MEMORANDUM

Subject: Staff Recommendations for August 17, 2017 Planning Board Meeting

Date: August 14, 2017

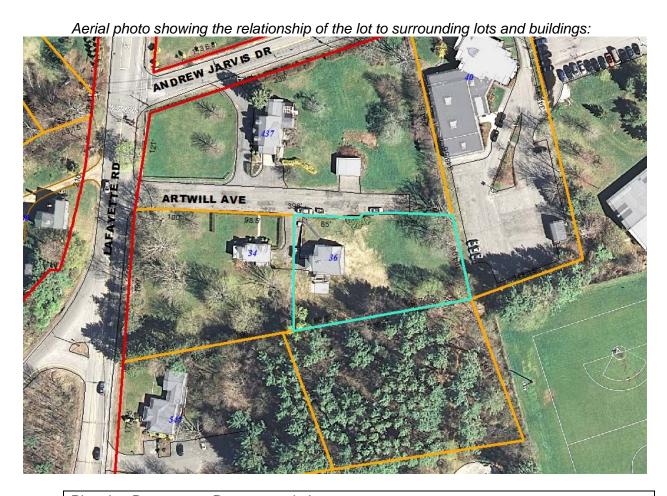
Required Standard	Planning Department Comments
The principal dwelling unit and the accessory dwelling unit shall not be separated in ownership.	
Either the principal dwelling unit or the accessory dwelling unit shall be occupied by the owner of the dwelling.	The owner is required to provide documentation demonstrating to the satisfaction of the City that one of the units is the owner's principal place of residence. The current owner is in the process of preparing the property for re-sale and does not plan to live in either the primary residence or the accessory unit. However, because the current garage which includes a space for a living unit on the second floor was built illegally by the previous owner, the City is requiring the owner to apply for and receive all required land use approvals before he can be authorized to continue work on the property. For this reason, he has requested that the Planning Board approval of the ADU be contingent upon a future sale of the property. Therefore, the Planning Board approval would need to stipulate that a certificate of use would not be issued until the new owner has occupied the property.

to comply with the 600 sq. ft. GFA. With the larger GFA and as currently designed, the DADU would be more akin to a principal dwelling than an accessory unit. Having two principal dwellings on a lot is not consistent with the intended purpose of a single family residential district and a similar request was denied by the Zoning Board of Adjustment in the past for this reason. The DADU shall be separated from the single- The proposed DADU will be 10.2' from the principal dwelling. The applicant's argument for requesting a		
GFA and as currently designed, the DADU would be more akin to a principal dwelling than an accessory unit. Having two principal dwellings on a lot is not consistent with the intended purpose of a single family residential district and a similar request was denied by the Zoning Board of Adjustment in the past for this reason. The DADU shall be separated from the single- The proposed DADU will be 10.2' from the principal dwelling. The applicant's argument for requesting a

should consider this application as if it were new		
construction and, if there is no other reasonable		• •
justification for why the DADU has to be closer than		•
what is required, then the 20' requirement should be		1 2
complied with.
